Pioneer Square Clinic Decorative Gate

Seattle Indian Health Board

PROJECT NAME SIHB Artwork and Security Gate ARCHITECT CONTACT Mario Campos mmcampos@jonesandjones.com

PIONEER SQUARE PRESERVATION BOARD - APPLICATION CORRECTIONS 01

Construction Design

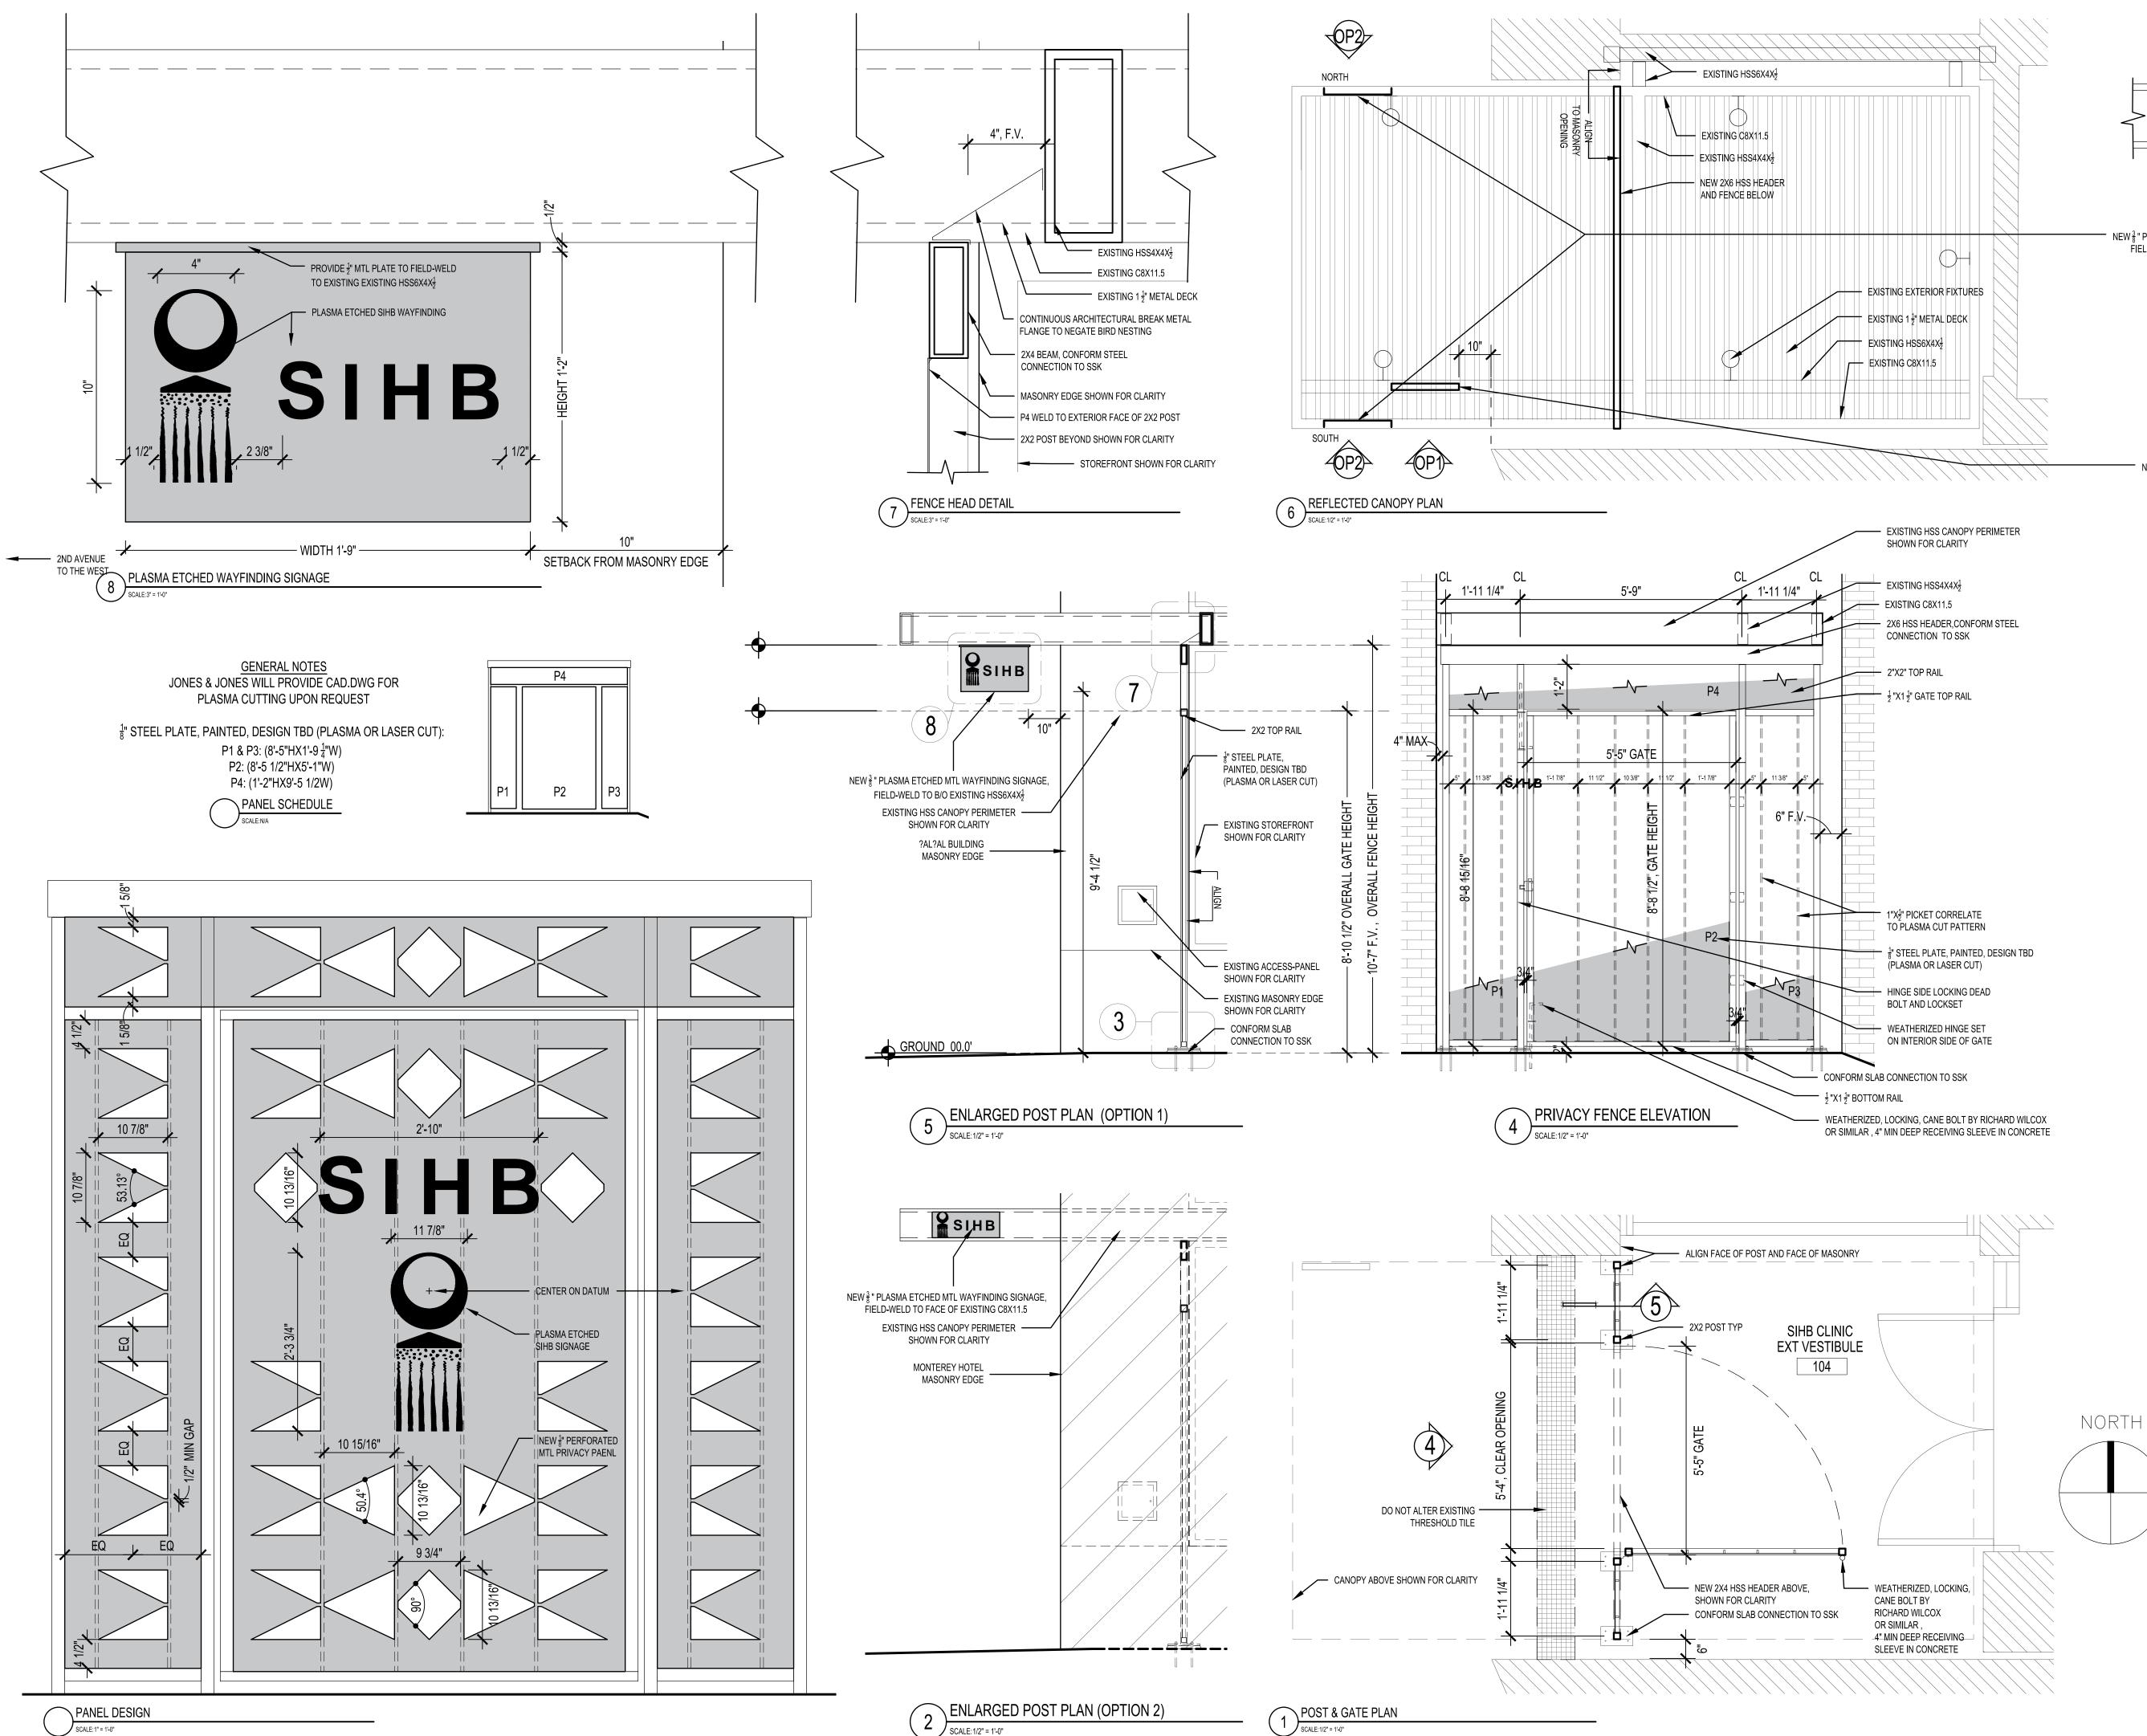
- 04. Please provide finishes, materials and color samples for the material used for the sign. Alternatively provide a photo of a similar sign.
- 05. Please provide finishes, materials, and color samples for the signs or alternatively a photo of a similar sign. Particularity for this option, you may want to show how the sign contrasts with the dark color of the existing metal it is attached to.

- 01. The intent of the security gate is to be secured open with locking cane bolt during hours of operation. The only situation where the gate will be operated is the opening and closing of the facility. We can provide an alternate design to create transparency if required.
- 02. We can provide an alternate design to create transparency dependent on PSPB response of Comment No 01.
- 03. That is a correct assumption, please see Plan Set_SIHB - 2nd ave security gate 20230207 Corrections 01 for a copy showing only the final design to reduce any confusion.
- *04.* Please see Material Samples_SIHB 2nd ave security gate 20230207 Corrections 01
- 05. Please see Material Samples_SIHB 2nd ave security gate 20230207 Corrections 01
- 06. Hanging blade option is two sided

Geometric Design

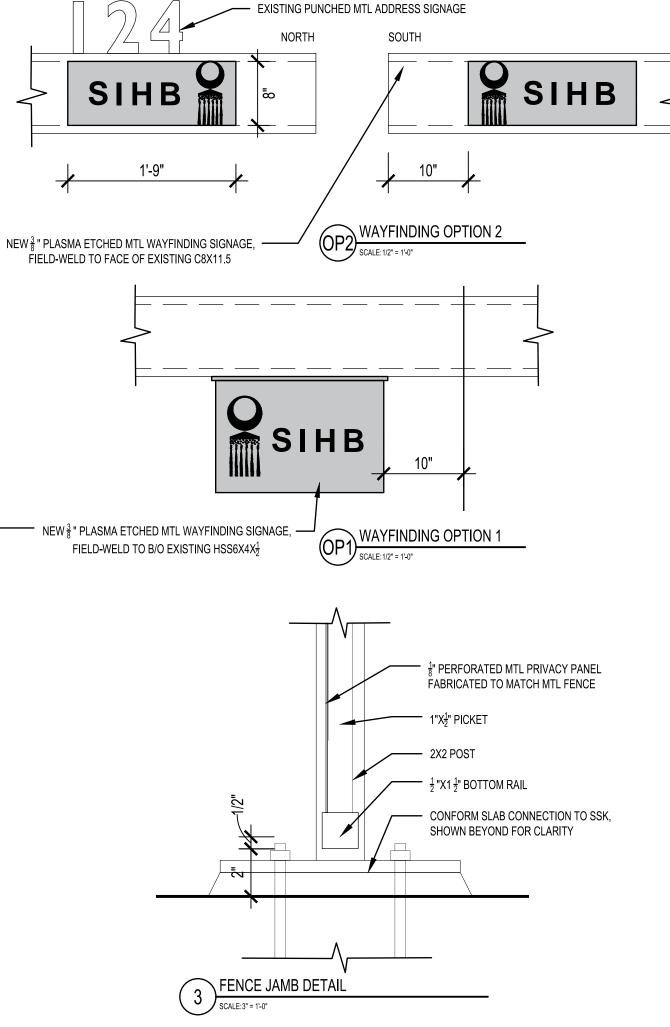
- 01. It appears that the solid nature of he gate head height (between 3' and 6' aff) will block transparency for people coming and going from a CPTED point of view, potentially creating a safety issue. Have you considered this issue?

- *02.* Have you considered an alternative that has a more transparent material behind this sign portion that allows people to assess the safety outside the gate when leaving?
